**AVON GROVE CHARTER SCHOOL
STATE ROAD HVAC RENOVATIONS
KITCHEN AND OFFICES**

ADDENDUM NO. #2

12/05/24

This Addendum is a summary of clarifications, interpretations, corrections and/or modifications to the Contract Documents for the AGCS – State Road HVAC Renovations Kitchen and Offices dated 11/18/2024 as prepared by Heckendorn Shiles Architects.

**DRAWING NUMBER
AD102**

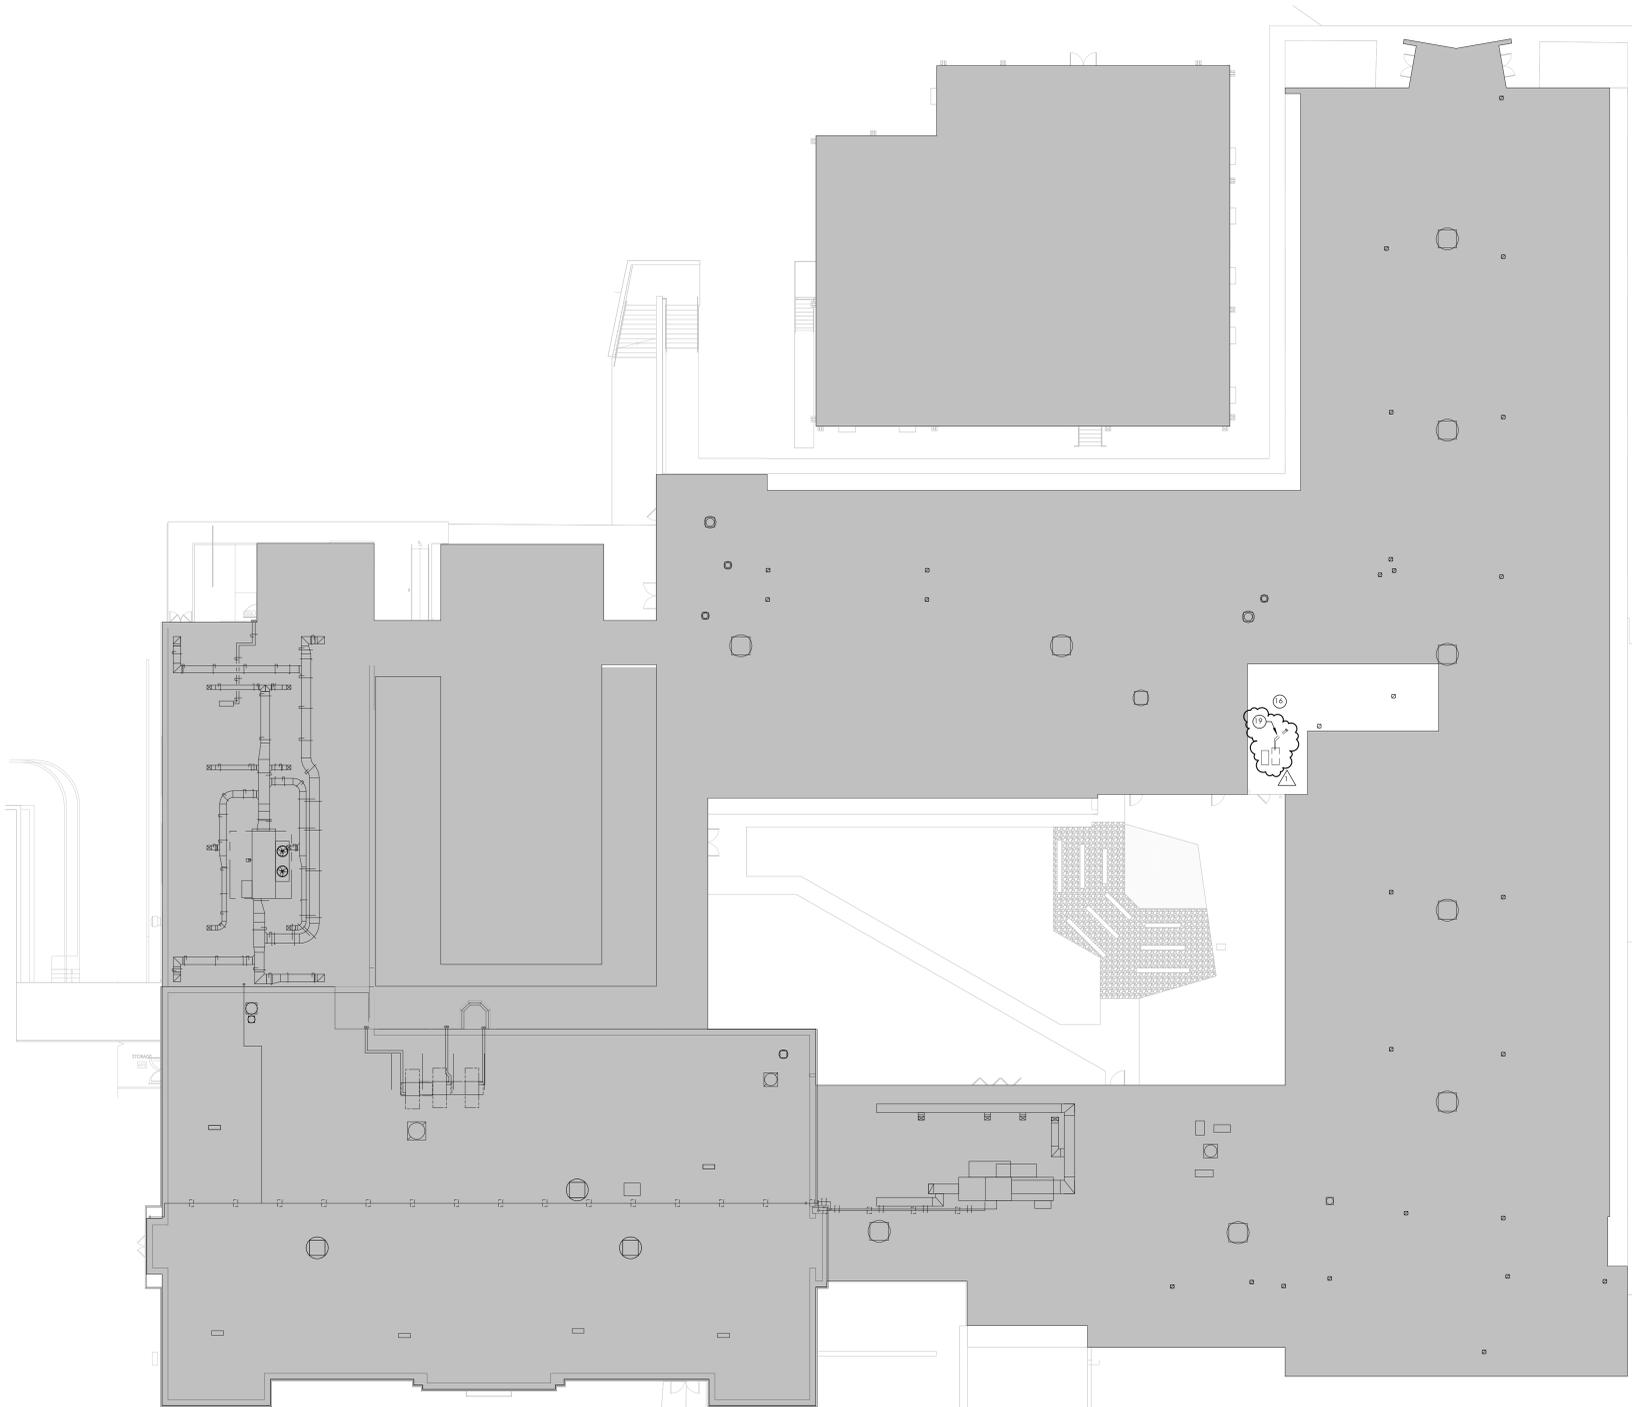
1. Drawing Update – AD102 and A102 – Clarification on roof scope.
2. Question: Drawing M401, Existing UV-14_Note states that condensate pump is to be installed in UV end panel enclosure. Is that end panel enclosure currently installed and it will fit new condensate pump and piping? Contractor doesn't need to provide the panel enclosure?
